**AQCF851BUFR**

**61408**

Vue éclatée

07471-05

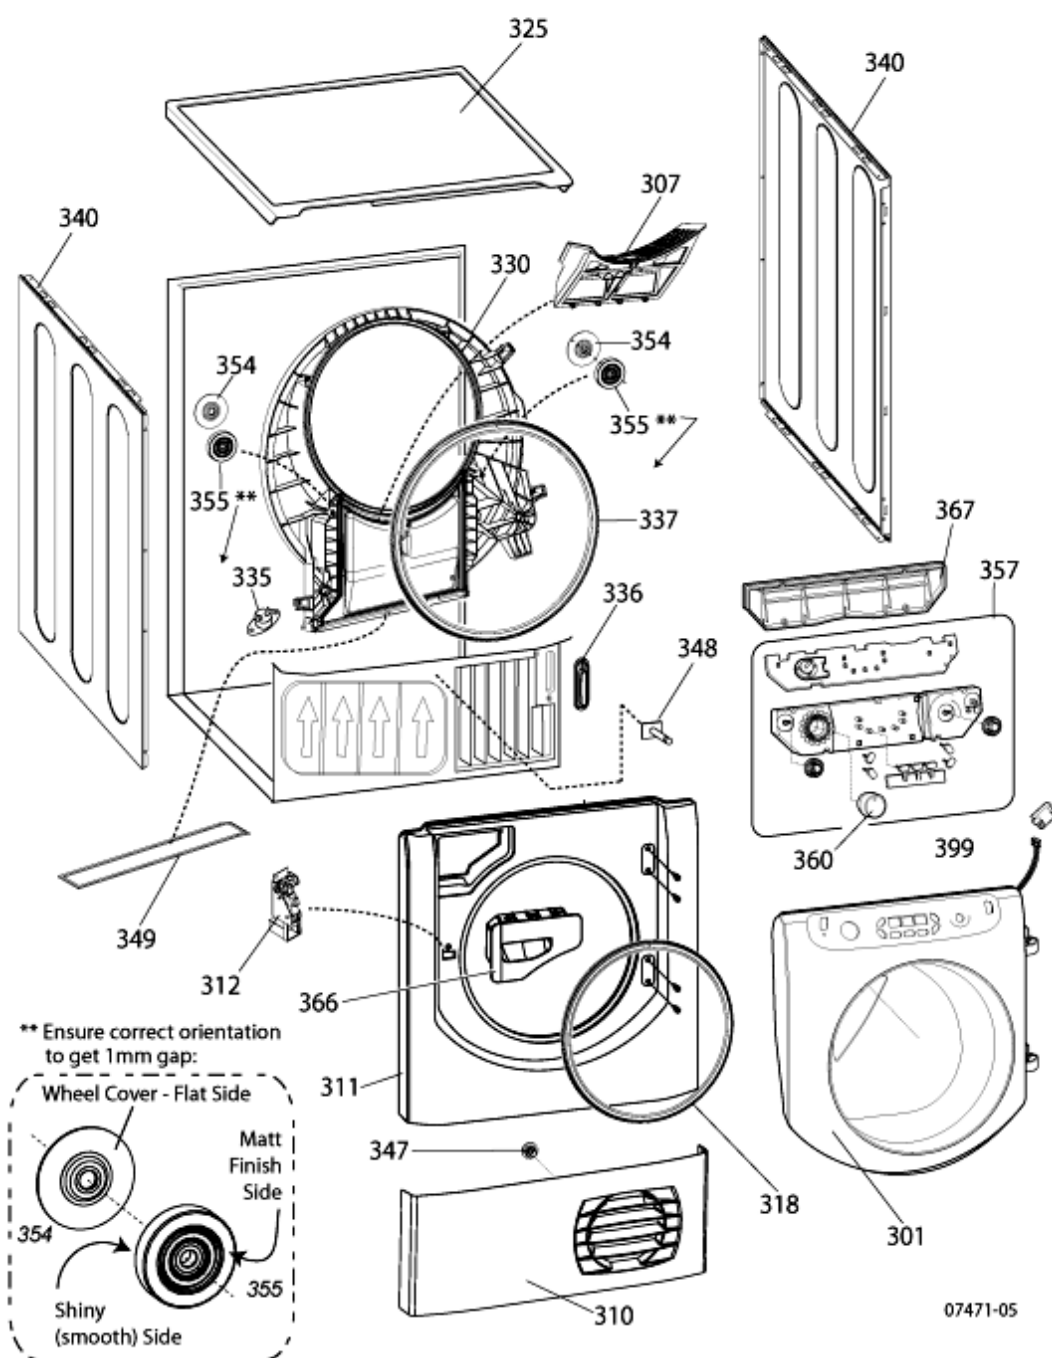
#### n4411g02: AQUALTIS TUMBLE DRYERS FILTERS

FROM JUNE 2011 THE FLUFF FILTER FITTED TO AQUALTIS TUMBLE DRYER CHANGED IN PRODUCTION FROM GREY TO WHITE.

#### n4411g03: AQUALTIS DOOR SEAL COLOUR CHANGE

ON SELECTED TUMBLE DRYERS FROM JUNE 2011 THE DOOR SEAL COLOUR CHANGED FROM GREY TO WHITE.  
SELECTED THE CORRECT PART BY DESCRIPTION IN THE PARTS LIST

#### n4411g08: COLOUR CHANGE FRONT AIR DUCT AQUALTIS DRYER

FROM JUNE 2011 THE FRONT AIR DUCT FITTED TO AQUALTIS TUMBLE DRYERS CHANGED IN PRODUCTION  
FROM GREY TO WHITE.  
SELECTED THE CORRECT PART BY DESCRIPTION IN THE PARTS LIST

07471-20

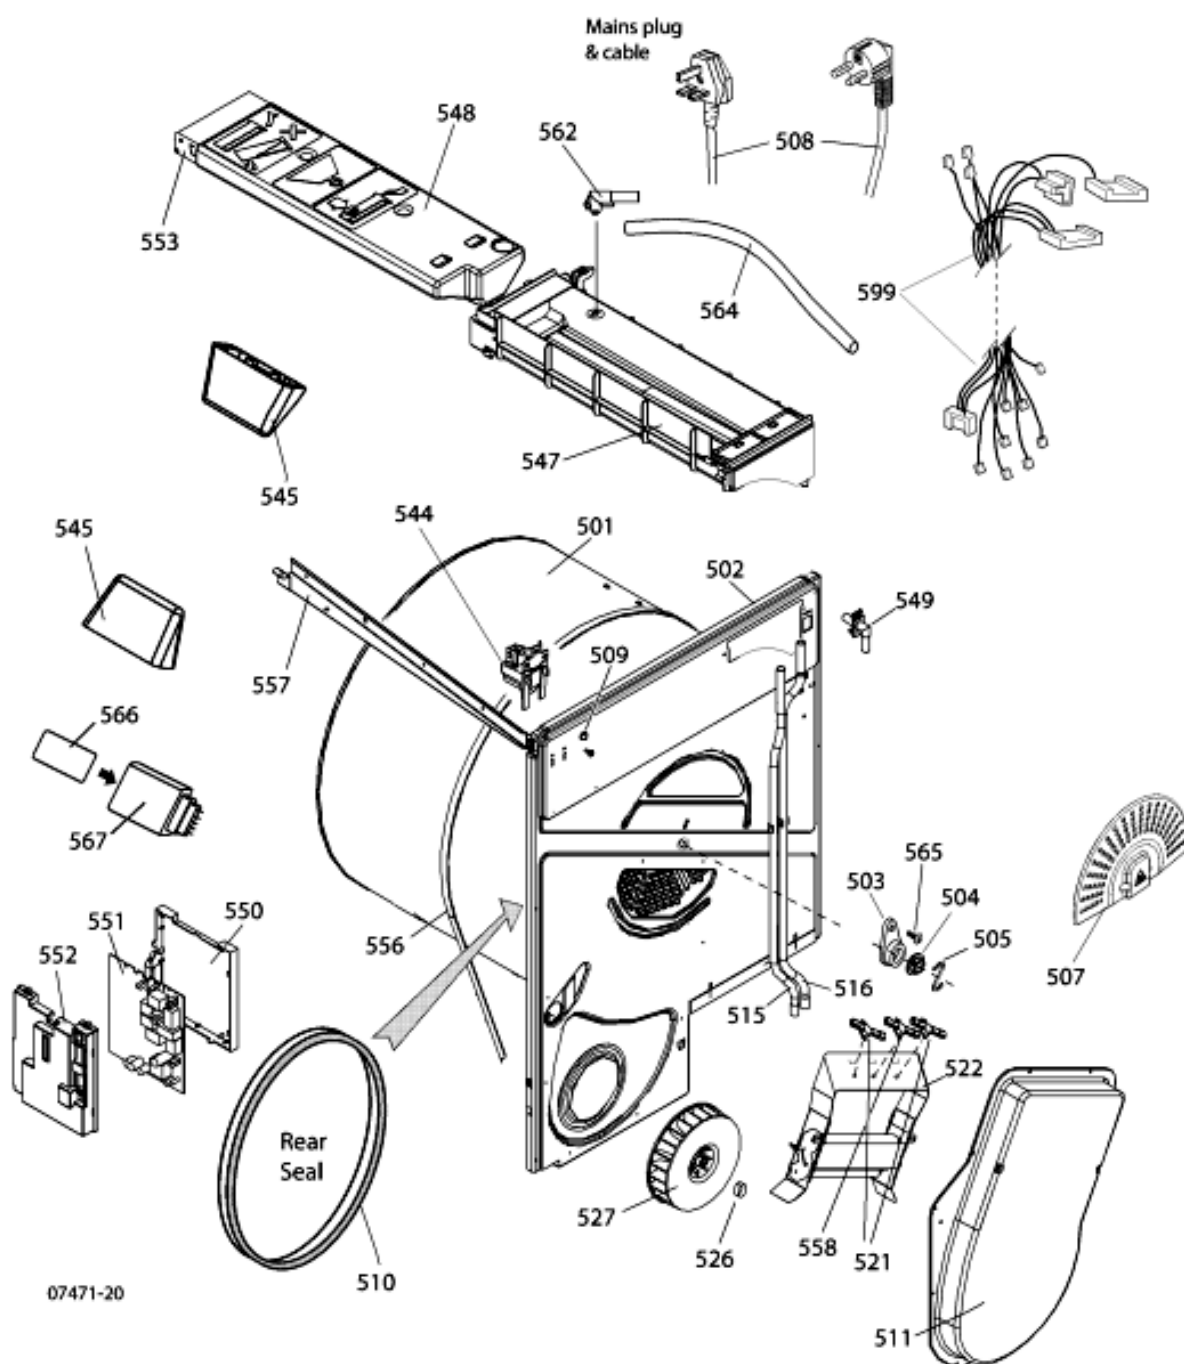
#### n4410j00: A2 MODULE-DELTA HEATER/BBC CHANGES

During week commencing 23/11/2009 Serial No.91123.0001 a new A2 power module and heater assembly was introduced in production. This change was gradually introduced starting from the above date with full production due by week commencing 2/01/2010 Serial No.100102.0001. During this period production may vary from the original build to the A2 build depending on availability of A2 components, so to enable easy identification for models produced with the A2 power module and heater assembly, there will be a circular BLUE label ( see Attached image) attached to the rear of the machine near the appliance rating plate. The label will be discontinued when full production of A2 module and heater is achieved on 02/01/2010.

From 16/08/2010, Serial No. 0816.0001 the build of some 7.Kg, 7.5Kg & 8Kg level 2 and level 3 B Energy rated condenser dryers changed to a new B Energy build using an A2 control module with 4.5.14 firmware along with a new type 362 motor and 2.3Kw insulated heater assembly.

#### n4411h00: CHANGES TO THE AQUALTIS DRUM AND LIFTERS

FROM JULY 2011 THE DRUM FITTED TO AQUALTIS TUMBLE DRYERS CHANGED IN PRODUCTION FROM PLAIN  
TO A TEXTURED INSIDE.  
WITH THIS CHANGE THE DRUM LIFTERS CHANGED FROM STRAIGHT TO CURVED.

# 07471-25 détachées

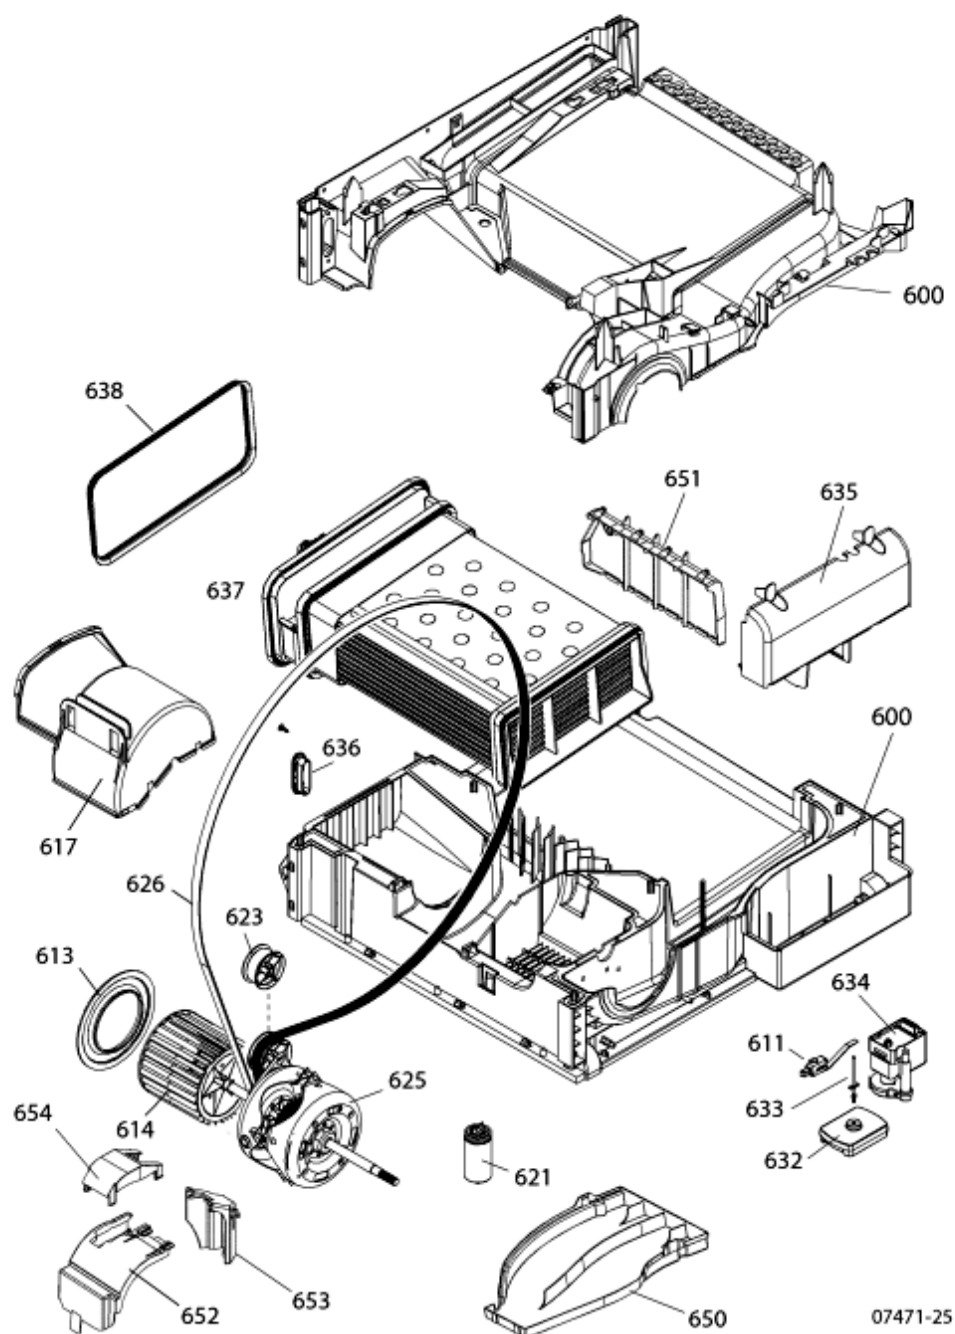
### n4409i00: Modification ventilateur

A partir du numéro de série 90914.0001, modification du ventilateur et de la bague de fixation.

En cas de remplacement du ventilateur sur des produits fabriqués avant ce numéro de série, commander le kit composé du nouveau ventilateur et de la bague de fixation.

#### n4410f01: B Energy BOM Changes

From 16/08/2010, Serial No.0816.0001 the build of some 7.Kg, 7.5Kg & 8Kg level 2 and level 3 B Energy rated condenser dryers changed to a new B Energy build using an A2 control module with 4.5.14 firmware along with a new type 362 motor and 2.3Kw insulated heater assembly. The base unit is based on the Aqualtis B Energy but using the C Energy type condenser unit with the base duct and motor covers removed.
